Well Name: KINBETO RG FEDERAL	Well Location: T23N / R10W / SEC 8 / NWNE / 36.24571 / -107.91618	County or Parish/State: SAN JUAN / NM
Well Number: 1	Type of Well: OIL WELL	Allottee or Tribe Name:
Lease Number: NMNM13956	Unit or CA Name:	Unit or CA Number:
US Well Number: 300452508700S1	Operator: DUGAN PRODUCTION CORPORATION

Type of Submission: Notice of Intent	Type of Action: Plug and Abandonment
Date Sundry Submitted: 07/16/2025	Time Sundry Submitted: 07:45
Date proposed operation will begin: 08/04/2025

CONDITIONS OF APPROVAL

Notice of Intent - Plug and Abandonment

Planned P & A Wellbore Schematic

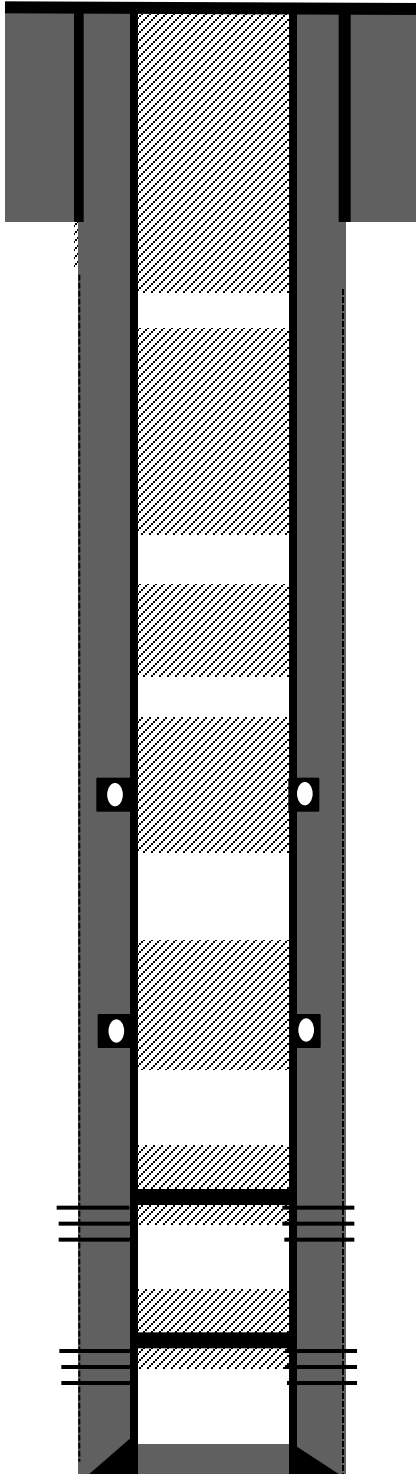
- a. Adjust Plug 2 (Mancos/DV Tool) TOC to 3235' to cover BLM Geologist's Mancos formation top pick @ 3335'. Plug 2 should at a minimum cover 3285' – 3748'.

- b. Adjust Plug 3 (Mesaverde/DV Tool) to cover BLM Geologist's Cliffhouse formation top pick @ 1980' and DV Tool @ 1955'. Plug 3 should at a minimum cover 1880' – 2030'.

- c. Adjust Plug 4 (Chacra) BOC to 1615' to cover BLM Geologist's Lower Chacra Formation top pick @ 1565'. Plug 4 should cover at a minimum 1120' – 1615'.

- Modify Plug 2: Move the TOC to 3235' to cover the BLM geologist's pick for the Mancos.

- Modify Plug 3 to cover the BLM geologist's pick for the Cliff House . The TOC may be moved as far down as 1880'. Move the BOC to 2030'

-Modify Plug 4: Move the BOC to 1615' to cover the BLM geologist's pick for the lower Chacra.
